Access Compliance Report

Public Rights-of-Way

(Curb Ramps)

Intersection ID: 10148	Main Street: TUCKASEEGEE_RD	Cross Street: MARMAC_RD	Location: NE
ADA ID: 45A8B02ABB0D	Ramp Type: BlendTrans1	Initial Pass/Fail: Fail	Overall Compliance: No
Severity Score: 8.75			
Codes/Mitigation Info/Possible Solution		Field Measurements/Component Compliance

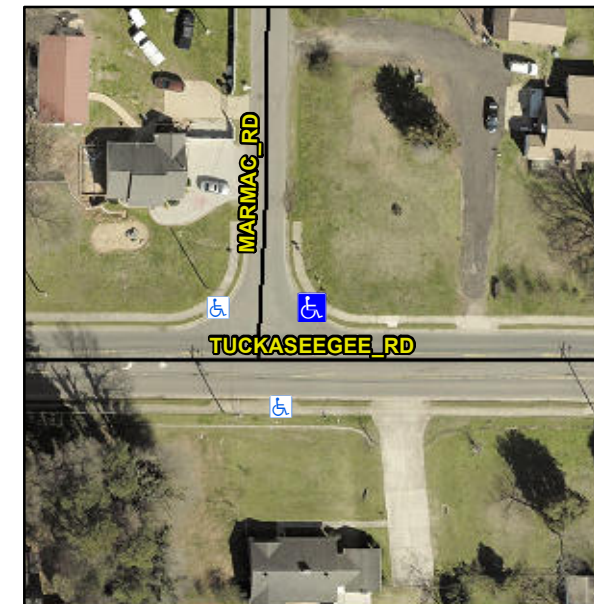
Not Found, R304.5.1

Compliance	Description	Data	Compliance	Description	Data
N/A	Ramp Length (in)	83.5	Yes	BlendTrans Slope (%)	3.8
No	Ramp Width (in)	38.5	Yes	BlendTrans XSlope (%)	0.2
N/A	Flare Type LT	N/A	N/A	Flare Type RT	N/A
N/A	Flare Slope LT (%)	N/A	N/A	Flare Slope RT (%)	N/A
N/A	Flare Traversable LT?	N/A	N/A	Flare Traversable RT?	N/A
N/A	Landing Length (in)	N/A	N/A	DWS Provided?	N/A
N/A	Landing Width (in)	N/A	N/A	DWS Contrast?	N/A
N/A	Landing Slope (%)	N/A	N/A	DWS Length (in)	N/A
N/A	Landing X Slope (%)	N/A	N/A	DWS Full Width?	N/A
N/A	Landing Curb? (Y/N)	N/A	N/A	DWS Offset (in)	N/A
N/A	Shared Landing?	N/A			
N/A	Gutter Ponding?	N/A	N/A	Gutter Slope (%)	N/A
N/A	Gutter Lip Ht (in)	N/A	N/A	Gutter X Slope (%)	N/A
N/A	Painted X Walk1?	No	N/A	Painted X Walk2?	No
	X Walk 1 Direction	To W		X Walk 2 Direction	To S
	X Walk 1 Width (in)	N/A		X Walk 2 Width (in)	N/A
	X Walk 1 Slope (%)	3.4		X Walk 2 Slope (%)	0.7
	X Walk 1 X Slope (%)	0.6		X Walk 2 X Slope (%)	1.9

N/A	Ramp inside XWalk1?	N/A	N/A	Ramp inside XWalk2?	N/A
	Road Slope (%)	0.5		Clear Space?	N/A
	Road X Slope (%)	2.4	N/A	Clear Space to XWalk (in)	N/A
N/A	Any Obstructions?	N/A	N/A	Storm Grate/Utility Hazard?	N/A
	Obstruction Type			Storm Grate/Utility Type	
		N/A			N/A
			Yes	Surface Condition? (G/P)	Good
			No	Curb Slope (%)	17.7

Remove & Replace Curb Ramp With Two New Directional Ramps or Equivalent.
